Ben Starchenko FK GARDNER & SONS	URGENT - Level 1 Rectification Alternative REQUEST FOR INFORMATION	20/08/2021 FKG-RFI-001227
Brendan Sutton PEDDLE THORP ARCHITECTS (BRIS)	Re: URGENT - Level 1 Rectification Alternative CONSULTANT ADVICE	20/08/2021 PTA 1-CADV-000998
Kent Radnedge FK GARDNER & SONS	Re: URGENT - Level 1 Rectification Alternative HEAD CONTRACTOR ADVICE	20/08/2021 FKG-HCADV-001029
Brendan Sutton PEDDLE THORP ARCHITECTS (BRIS)	Re: URGENT - Level 1 Rectification Alternative DESIGN CORRESPONDENCE	24/08/2021 PTA 1-DESCOR-001159
Matthew Markiewicz FK GARDNER & SONS	Fwd: URGENT - Level 1 Rectification Alternative GENERAL CORRESPONDENCE	24/08/2021 FKG-GCOR-007738
Matthew Markiewicz FK GARDNER & SONS	Re: URGENT - Level 1 Rectification Alternative GENERAL CORRESPONDENCE	27/08/2021 FKG-GCOR-007803
Matthew Markiewicz FK GARDNER & SONS	Re: URGENT - Level 1 Rectification Alternative GENERAL CORRESPONDENCE	30/08/2021 FKG-GCOR-007826

Atherton Hospital Redevelopment
Corner Jack and Louise St
Atherton
QLD 4883 Australia

CSB - Level 01 Slab Rectification Works

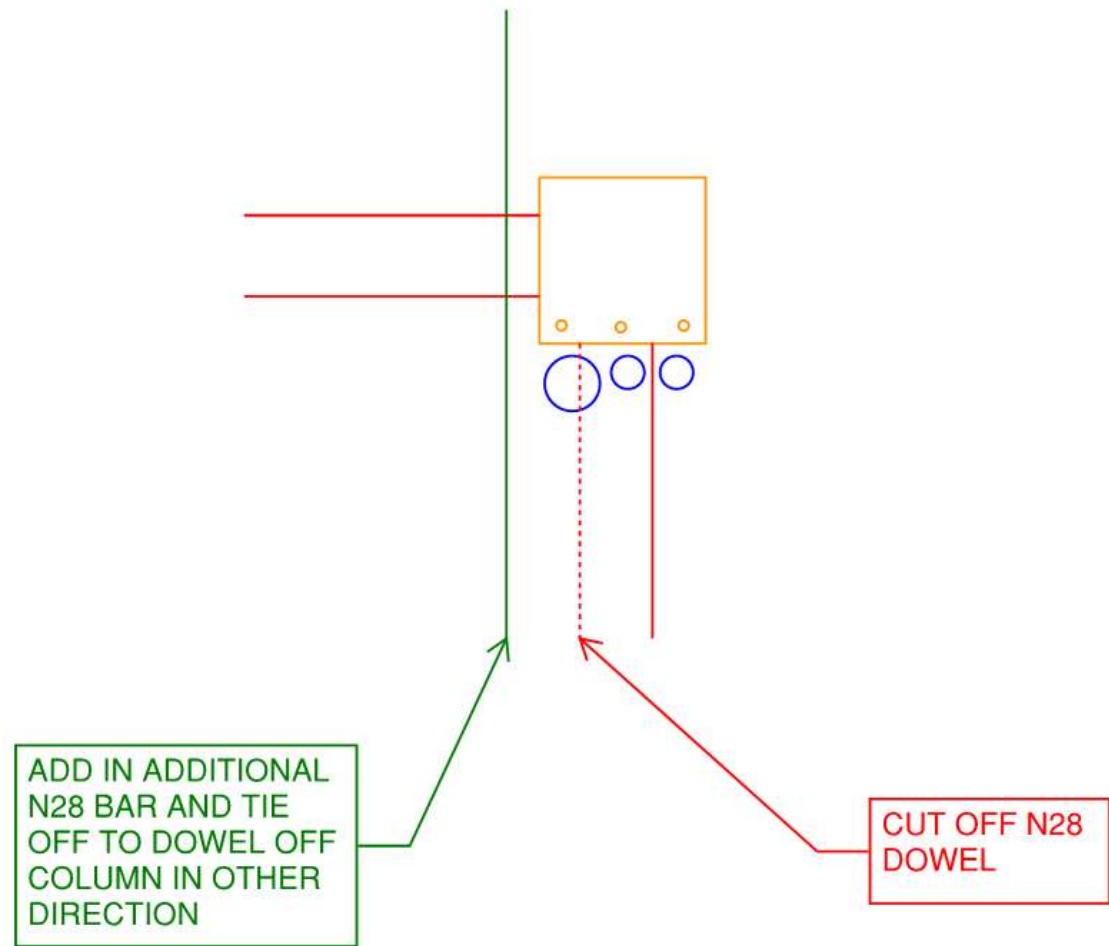
As discussed over the phone this morning, please note that we have a clash with the nominated N28 dowel bar and 150mm penetration for the hydraulics. Please see below column layout and penetrations on-site:

Please also see attached pictures of the reinforcement installed to the underside of slab and completed scabbling. Could you please review and advise if acceptable. These images also show the layout of the penetrations as we have discussed about this morning.

Are we able to cut off the dowel like below and add in the additional N28 bar tied off to the dowels in the other direction.

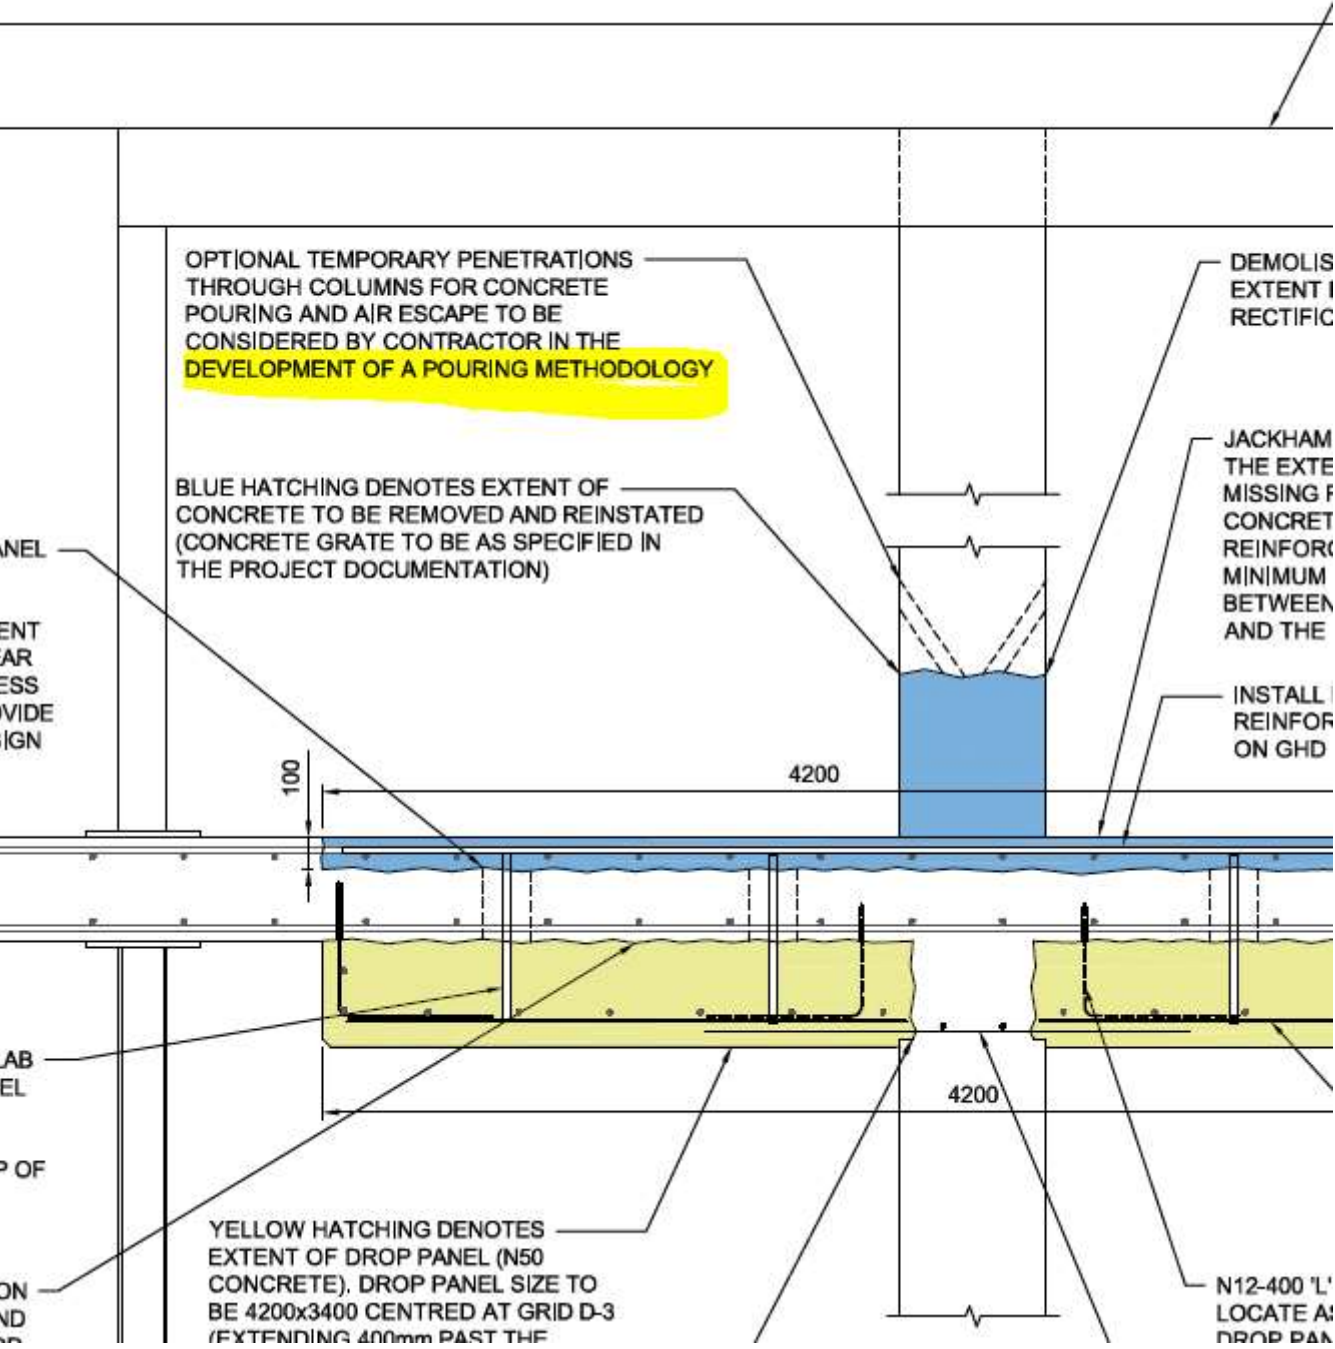
Please find attached a sample photo of the scabbling. The methodology for this scabbling is to etch the underside of the slab 10mm deep with a saw cut and then using the jackhammer to roughen up the area. FKG will continue with this scabbling method moving forwards.

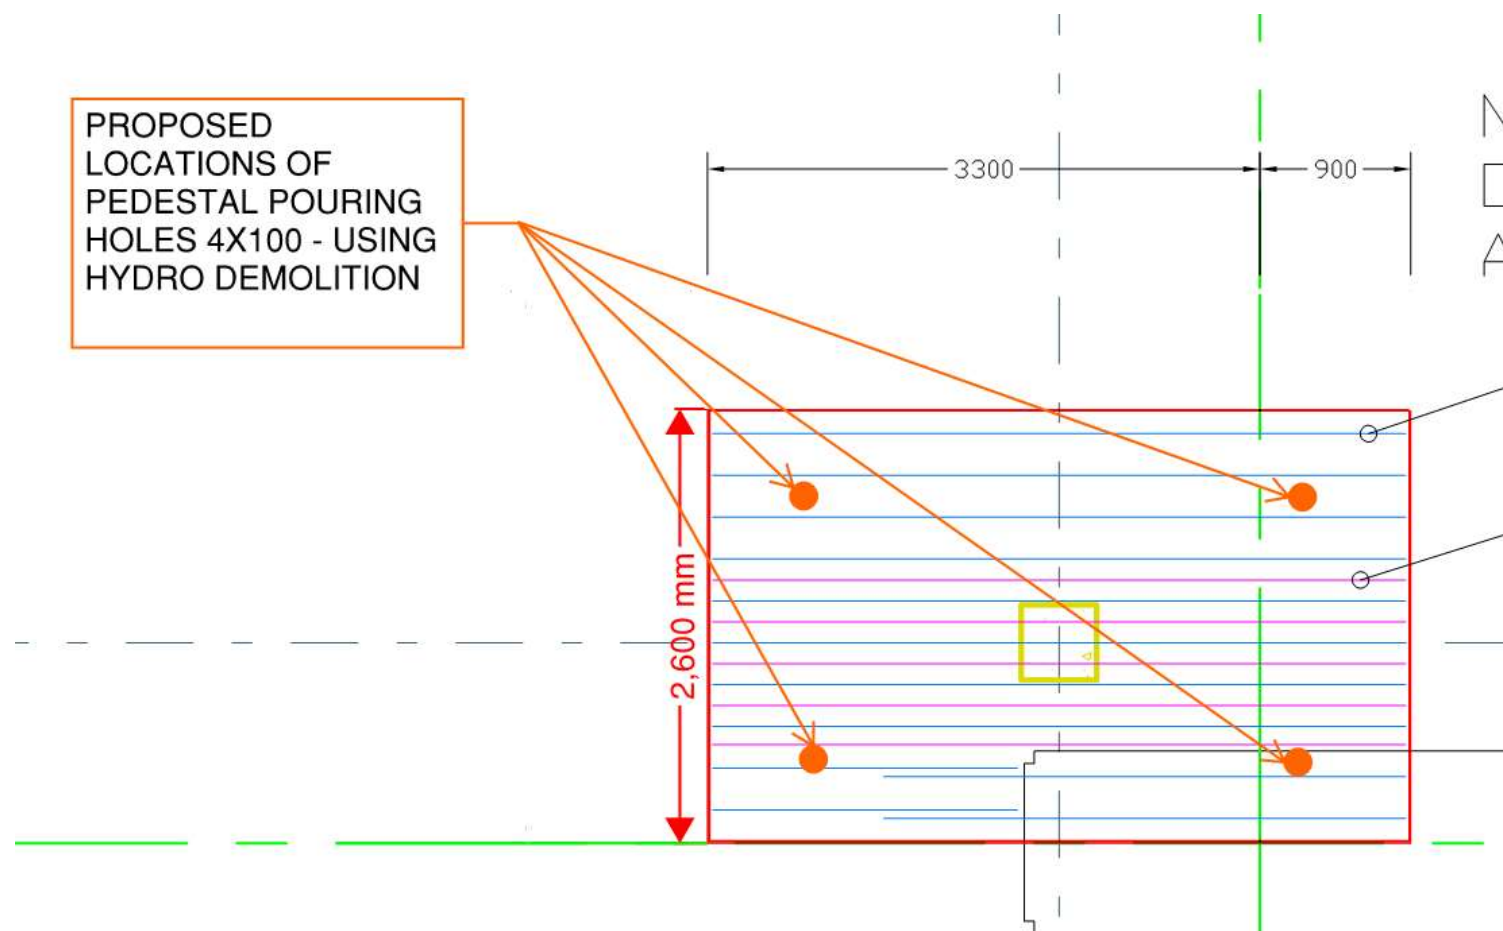
Please see below the 4 core hole locations proposed by FKG. Please note FKG would like to use hydro-demolition in these locations to ensure that no reinforcement is damaged and allow for a larger opening. The larger 100mm opening would allow for a concrete pump hose to get through the hole and be able to moved to ensure even and correct distribution of the concrete. This will also allow for the vibe to help move around the concrete to ensure no air pockets.

Please review proposal above and comment..

please provide proposed location and size of access holes for approval prior to coring these holes in the slab (as noted in the rectification detail provided).

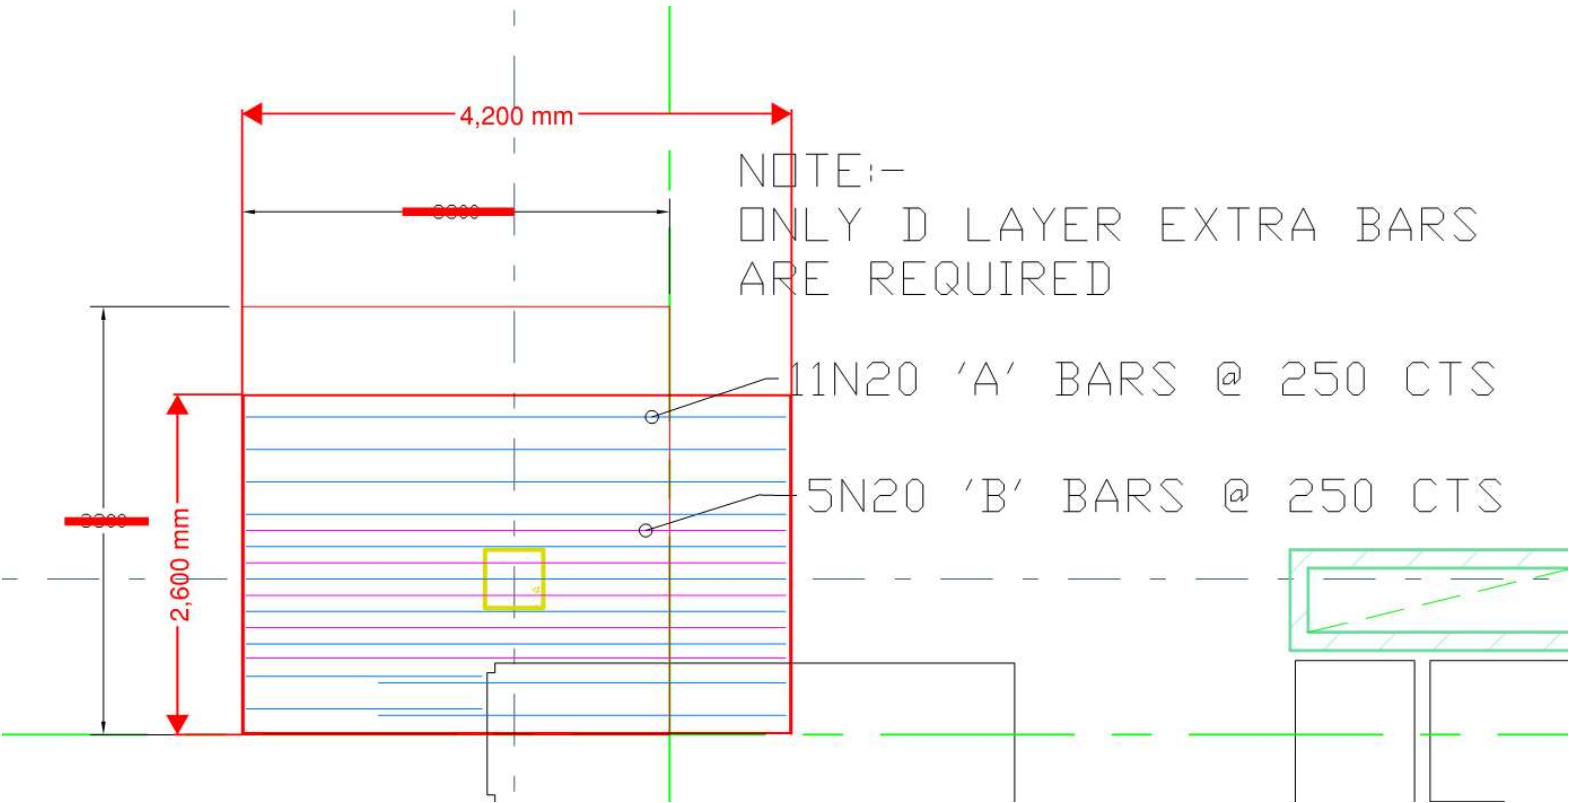
As discussed on the phone with Daniele this afternoon, please confirm if the below area of proposed demolition (4.2m x 2.6m) and potentially pedestal could be adopted during these rectification works.

The proposed demolition extent is acceptable. It is understood that on the southern side of grid 3 the demolition will extend up to the construction joint.

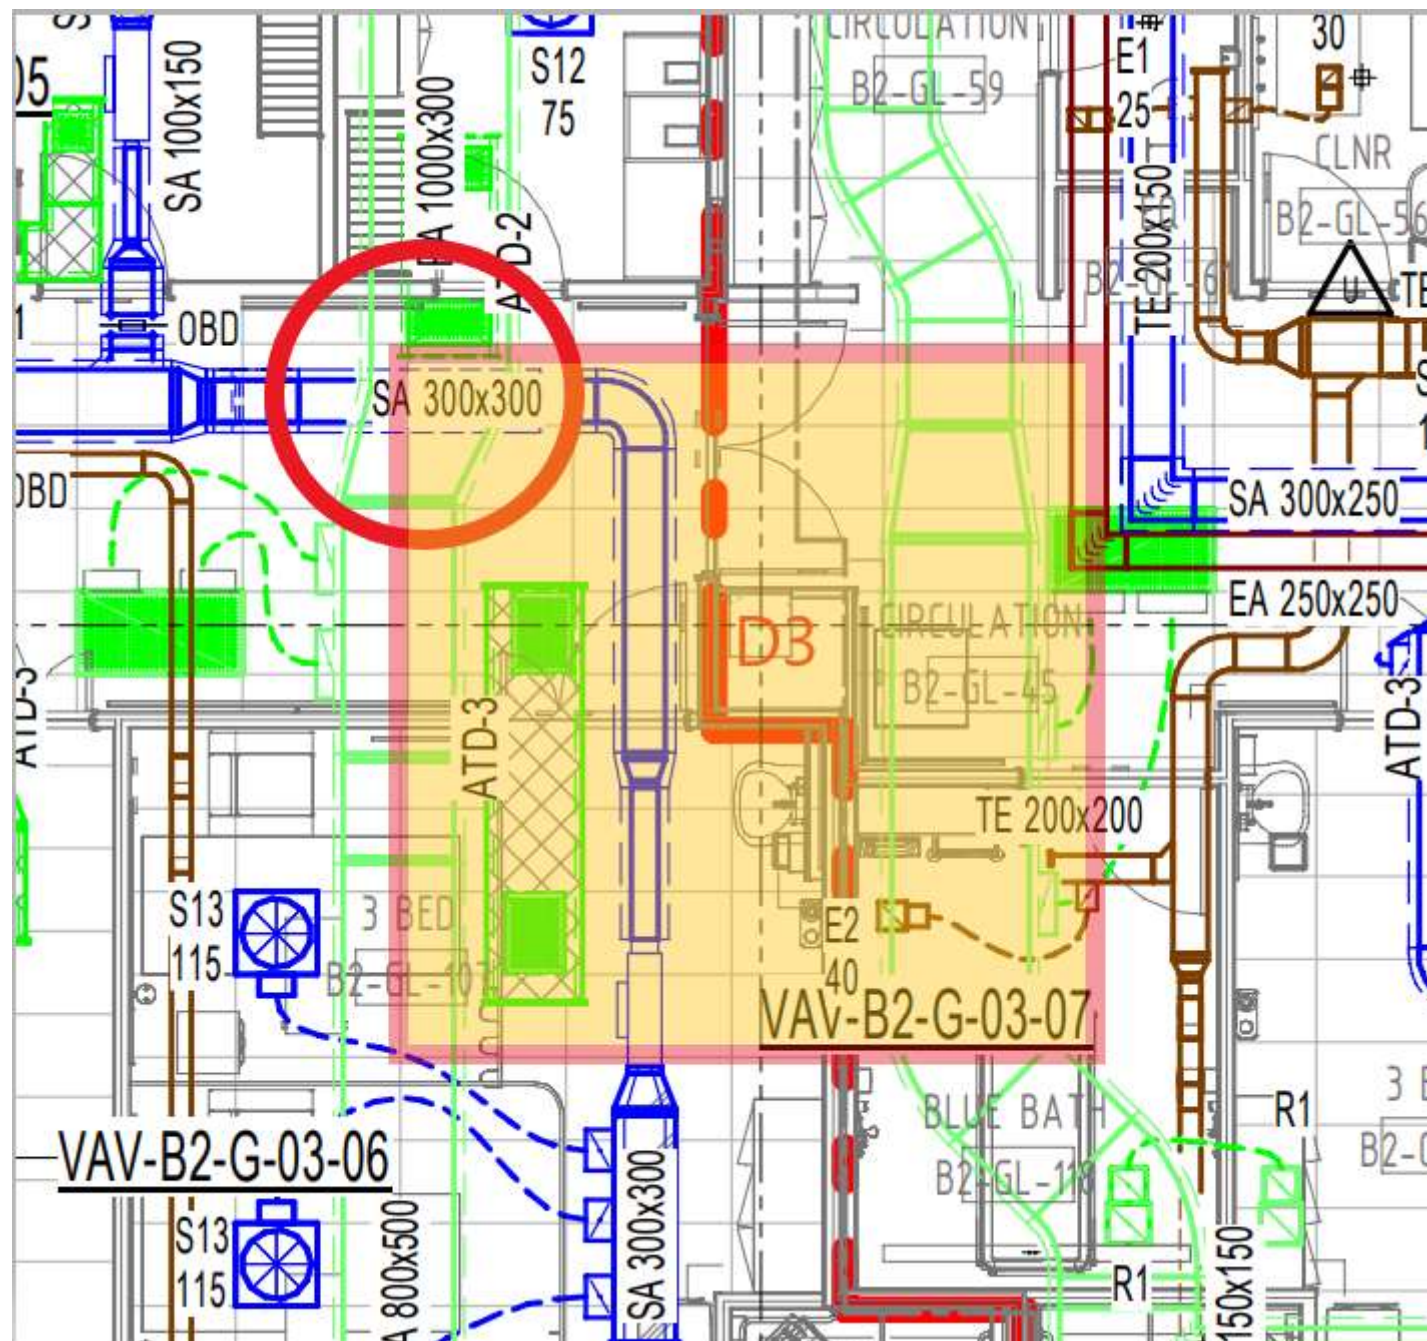
We note that it will have a minor clash with some of the mechanical ductwork shown circled below.

However we anticipate that this will be coordinated between yourselves and VAE?
